Daimler Trucks

North America LLC **Customer Advisory Letter**

Subject : Evolution APU No Regen

Models Affected: are New Cascadia built 2018 with ThermoKing Evolution APU.

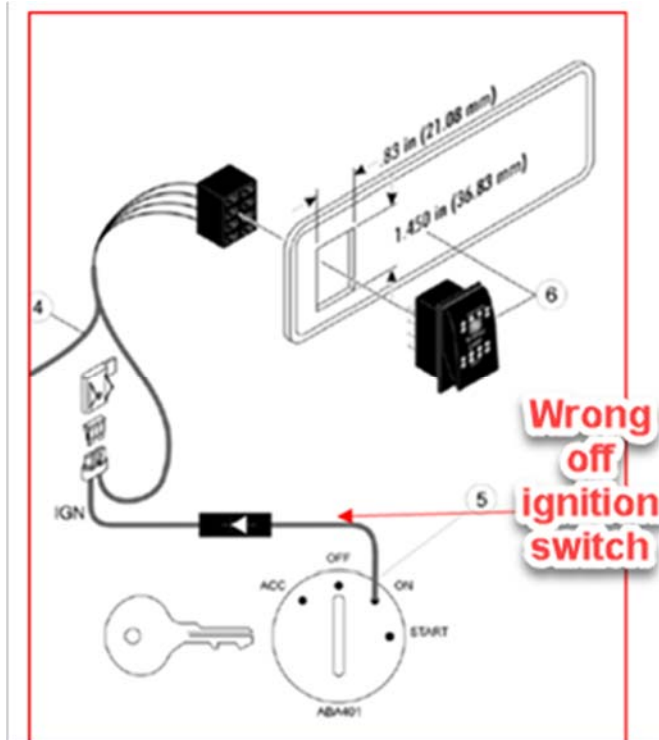
There may be reports of the factory installed APU not being able to perform a regen. Instructions from TK recommended the ignition power source be at the ignition switch. On the Cascadias', both New and Old designed models, the ignition switch is a signal and does not have 12 volts at any of the terminals. Accessory power must come from the recommended ignition source, Splice Packs. Splice Packs are the source where all accessories added in the cab should be sourced, you will find fused constant power (Fuse F35 10 AMP), fused ignition power (Fuse F44 10 AMP) and ground.

If the TK APU does not perform a Regen when requested. Access the rear of the ignition switch, if the power for the regen switch is connected, remove the lower left center of dash kick panel. You will see the splice packs located as the example below. Test the splice packs looking for the ignition controlled splice pack, there you will find fused constant power, ground and fused ignition splice pack. Use the correct wire terminal end to connect into the splice pack for the wire size you are attaching. Check with your Freightliner Dealer, they should be stocking some of these terminals.

When adding a circuit, the terminals (listed above) will plug into the rear of the connector, see the white part of the connector above, that connects all circuits plugged into the connector to distribute power. Photo below shows the Splice Pack of the connector removed to see how it connects circuits.
